**YEC 2023/24 GRA  
Undertaking  
Responses**

Attachment 1 to Undertakings Cover Letter – List of Undertakings and Responses

- March 6, 2024 Transcript, page 308, line 25 – page 309, line 2: To provide the inspection reports from Collicutt Energy, who did the inspection in 2021.

*Figure 1- Injector with Sheared O-ring*

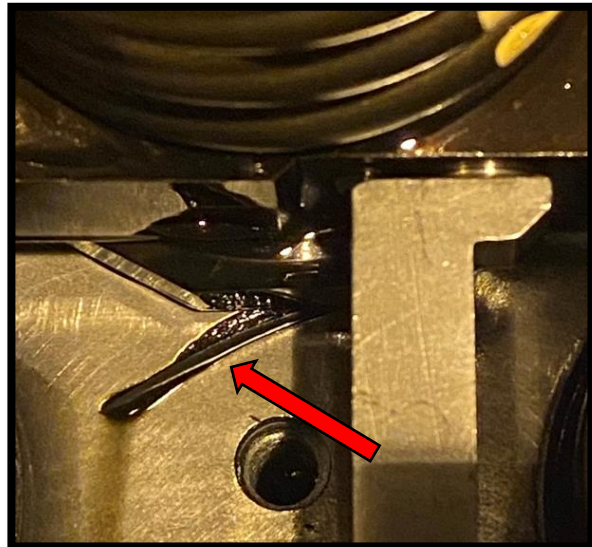
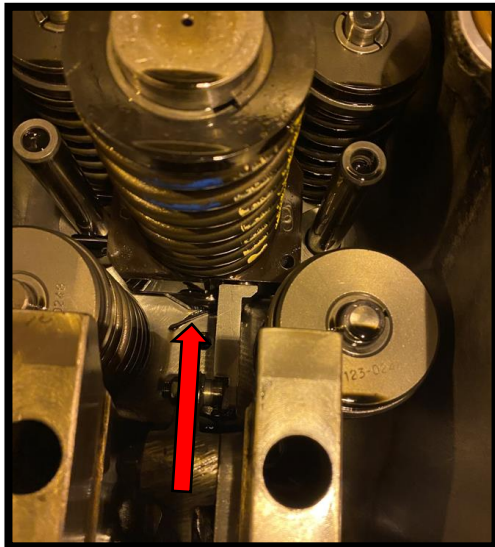
- Injectors #1 & #3 left
  - O-rings sheared off from previous install
- Injector #2 right
  - O-ring sheared off and visible
  - Injector spring is broken
    - Replaced with Cat reman injector

**Figure 1 – Injectors with sheared O-ring**

- **Q:** *Should we inspect the other injectors, or only if indicator makes itself known?*
  - **A:** *A visual inspection of all the injectors was completed while onsite. The two damaged O-rings were replaced with new and updated O-rings. As a precautionary measure, the remaining injector O-rings can be replaced with the updated O-rings. This could be planned at a scheduled repair or service interval. \*\*Added to Medium Level Recommendations list above.*

Figure 2- Front Dampener Guard - 7 Broken Tabs

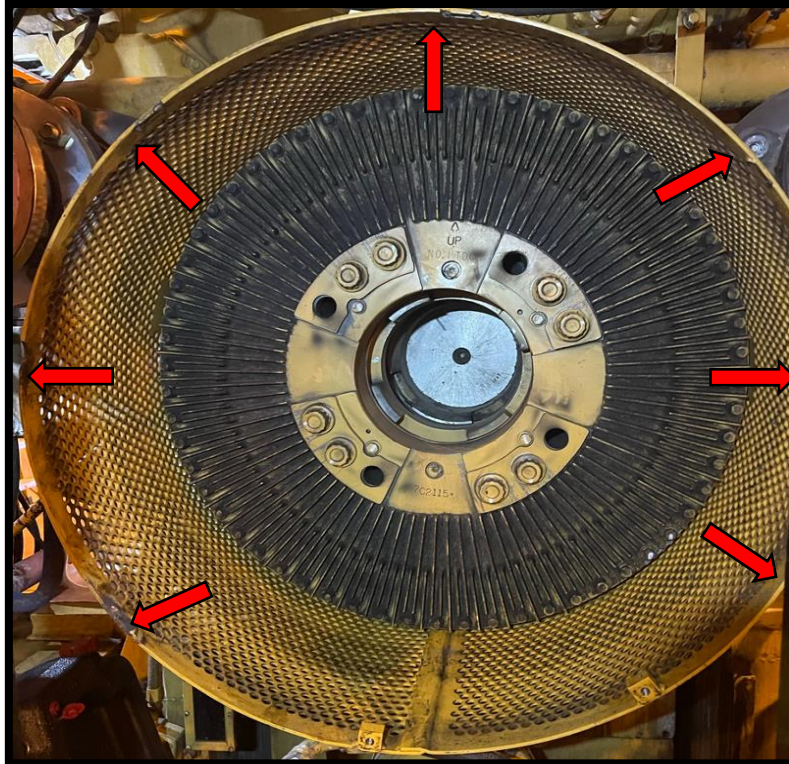
- Removed Aux In water piping to access vibration dampener guard
  - Noted 7 of 9 broken tabs on guard back and front
    - We repaired by welding tabs back onto the guard

*Figure 3 - Front Dampener Oil*

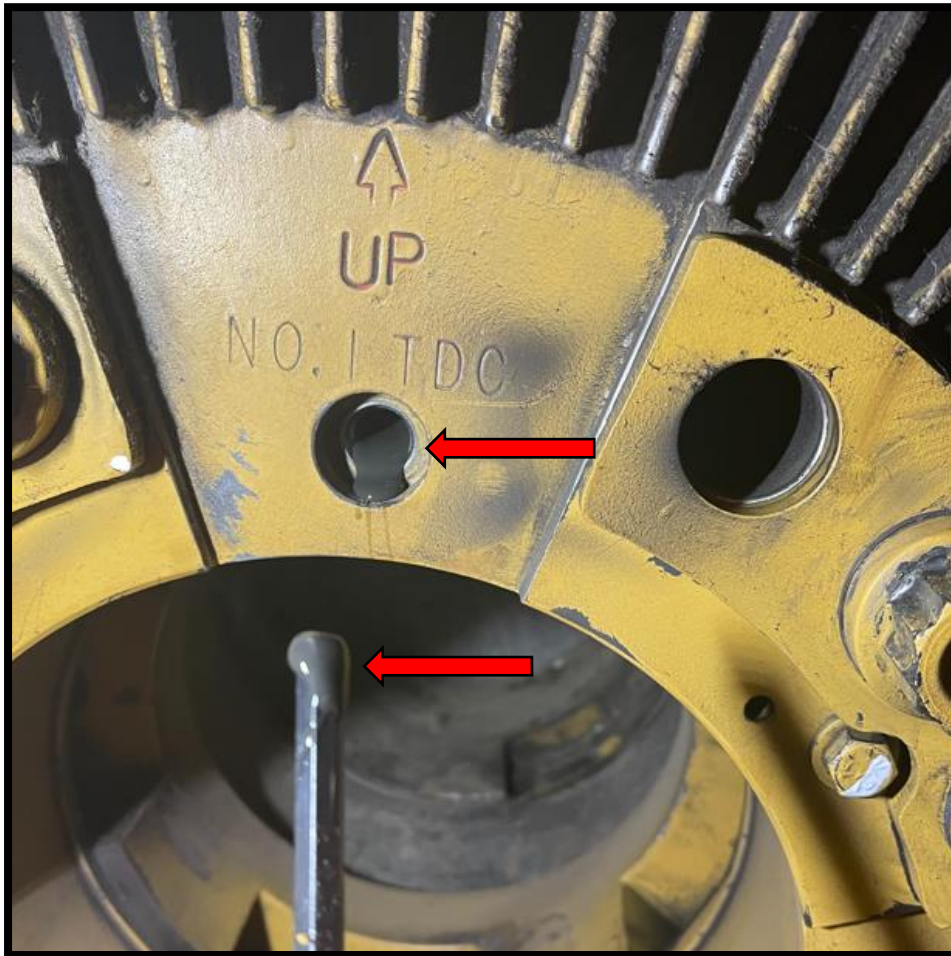
**Figure 3 – Front Dampener Oil**

- **Q:** *The oil is obviously contaminated. Should we change the oil, or is the oil in this condition because the dampener is failed?*
  - **A:** *The oil is contaminated with wear metals, most commonly from internal wear rings. This would require major cleaning, new internal components, as well as fluids. This is not a field serviceable item, we recommend replacing with a rebuild dampener.*

Figure 8- #4 Right Piston – Top Ring Chrome Flaking

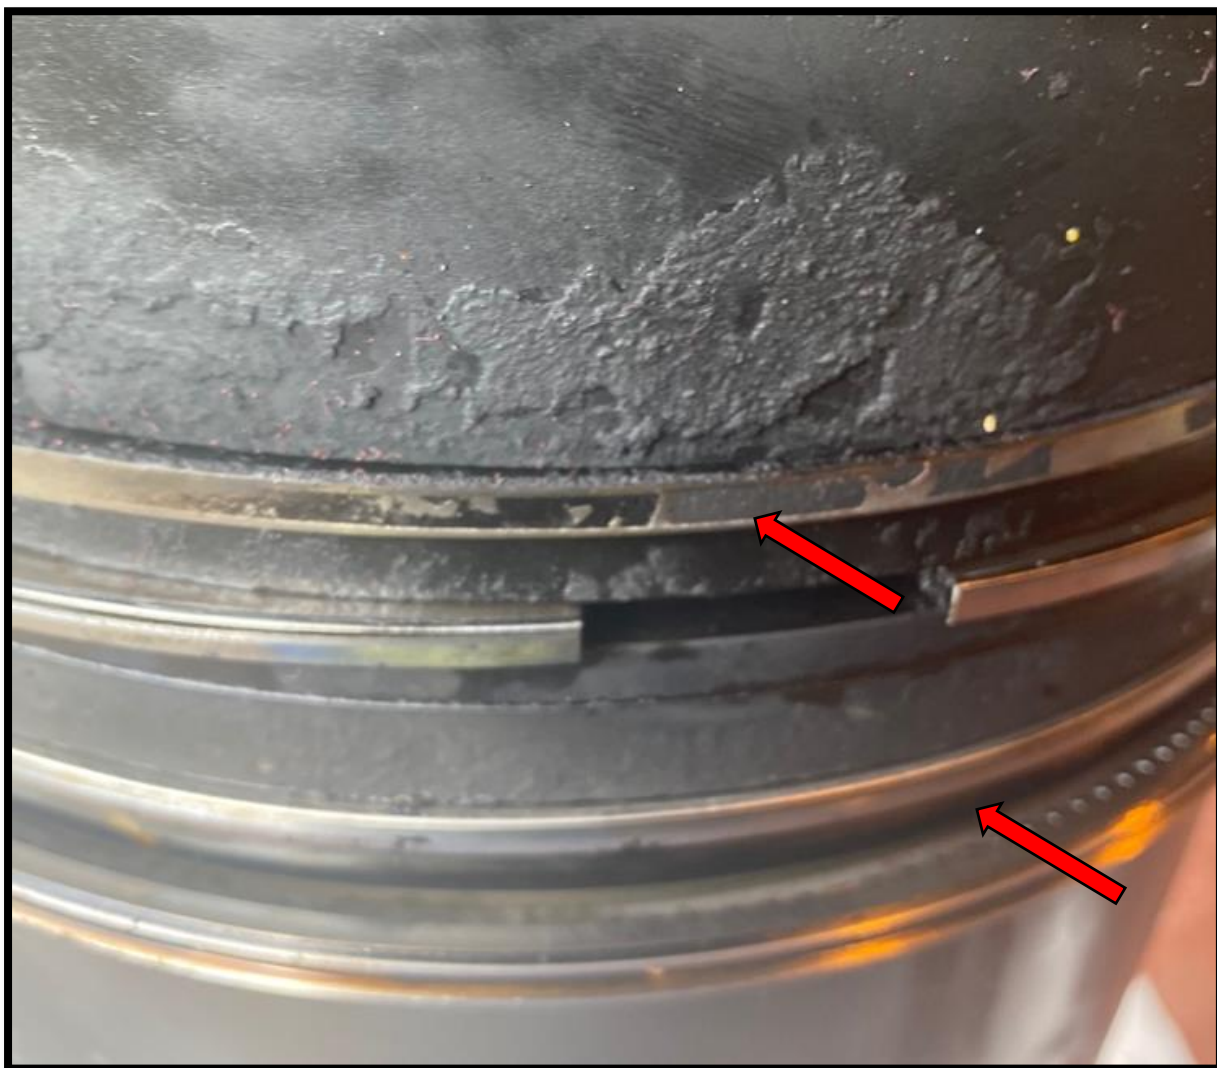
### **Figure 7 & 8 – #4 Right Piston Carbon Flaking, also Figure 24.**

- **Q:** *Are these conditions normal? Excessive? Minor? What's the impact? Need interpretation.*
  - **A:** *This is not a normal condition but also not excessive, this is most likely caused by higher sulfur levels in the diesel fuel. See figure 30 below.*

- *Identify your diesel fuel sulfur levels and verify the proper oil is being utilized to match the sulfur levels. See figure 31*
      - *\*\*Added to Immediate Level Recommendations list above.*

*Figure 25 - #5 Left Rod Bushing*

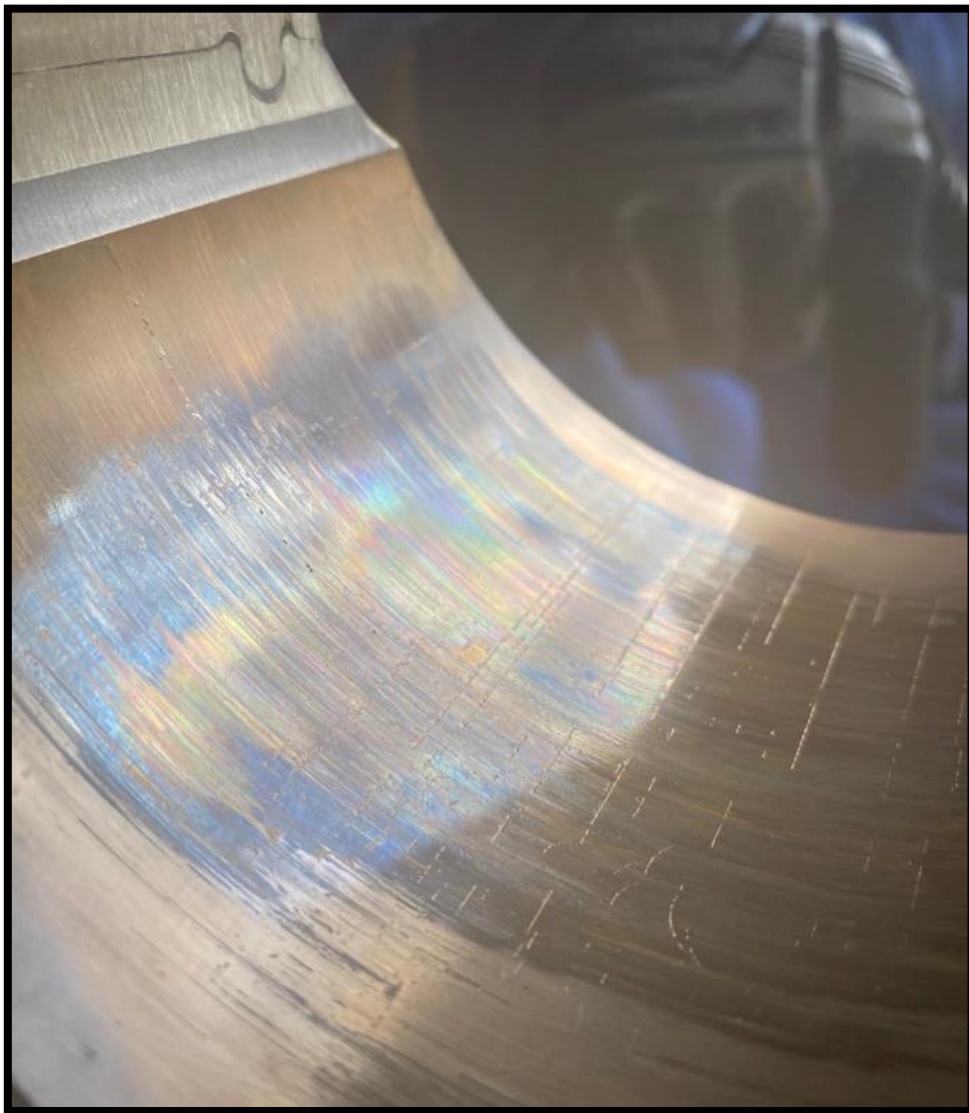
### Figure 25. Rod Bushing

- *Q: Appears to show discolored bushing surface. Is this normal?*
  - *A: This is not uncommon and could be another symptom of sulfur in fuel, causing acid in the oil. As recommended above, install vibration altimeter devices, and continue to operate. Routine oil analysis to confirm sufficient lubrication properties, and routine conditional monitoring to trend operational conditions.*

**Finding #1 – Engine, Power cylinder #2 & #16 – Leaking at peak firing pressure**

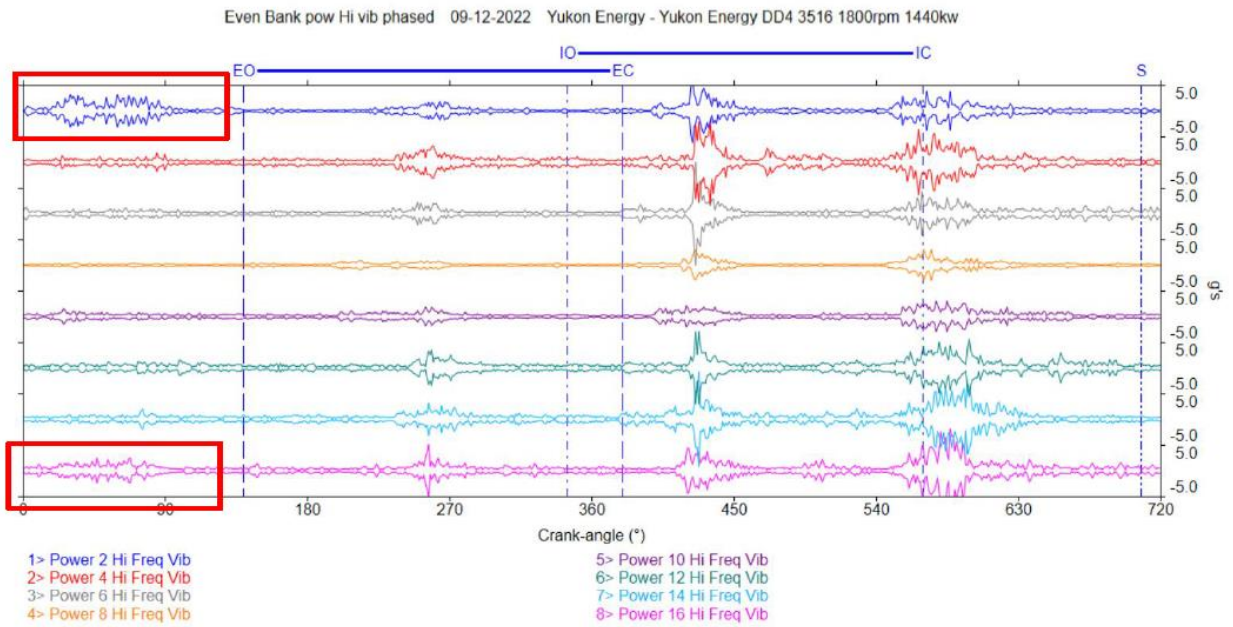
Finding	Observations	Recommendations	Data / Photos (Page #)
1	<b>Engine, Power cylinder #2, &amp; #16</b> – Ultrasonics show some evidence of leakage at and around peak firing pressure.	Replace cylinder liners and piston rings	18
2	<b>Engine, Power cylinder # 1, 3, 4, 14, &amp; 16</b> – Borescope inspection indicates cylinder liner wear.	Replace cylinder liners and piston rings	18
3	<b>Engine, Cylinder Head # 13</b> – Borescope inspection indicates valve seat contamination & exhaust leaking	Replace cylinder head	19
4	<b>Engine, Power cylinders #2, &amp; # 14</b> – Double closing events were noted in cylinder head ultrasonic traces.	Set valves as per OEM recommendations – corrected onsite*	19
5	<b>Top End</b> – There are significant valve cover and head gasket leaks	Replace gaskets at cylinder head replacement and or next service	20
6	<b>Generator Skid</b> – The isolation pads are not secure to the concrete floor. This is resulting in elevated vertical readings 4x’s recommended specifications.	Secure isolation pads to the concrete slab as per manufacturer recommendations.	21

**Finding #7 – Engine, Exhaust – Leak on turbo exhaust.**

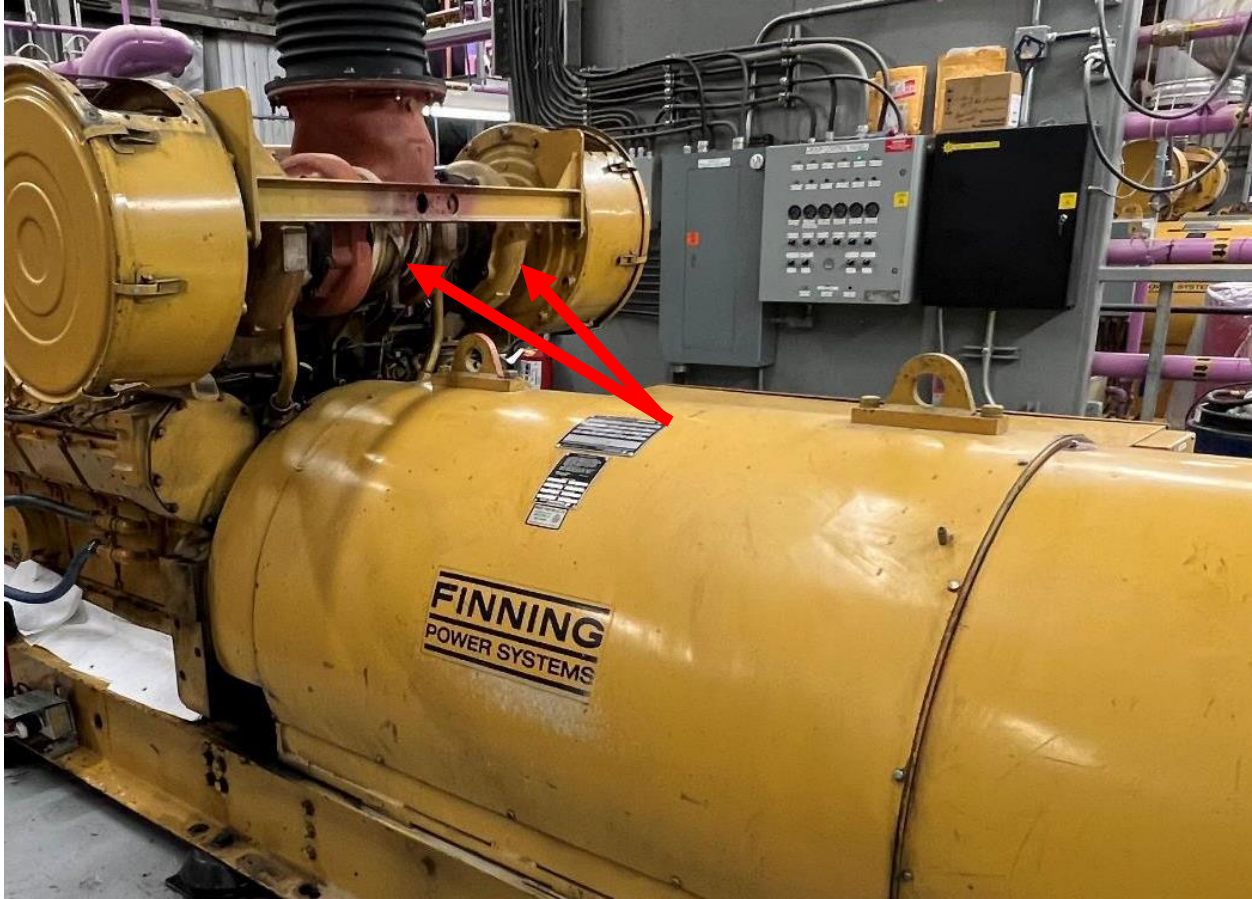
7	<b>Engine, Exhaust</b> – The ultrasonic survey picked up a leak on the turbo exhaust	Replace seals	22
8	<b>Engine, Air Intake</b> – Air filter housings had the opening upwards pulling in air heated by the hot exhaust	Rotate the air filter housing minimum 90 degrees to the back of the generator and ideally pointing the opening directly down like the other units	23
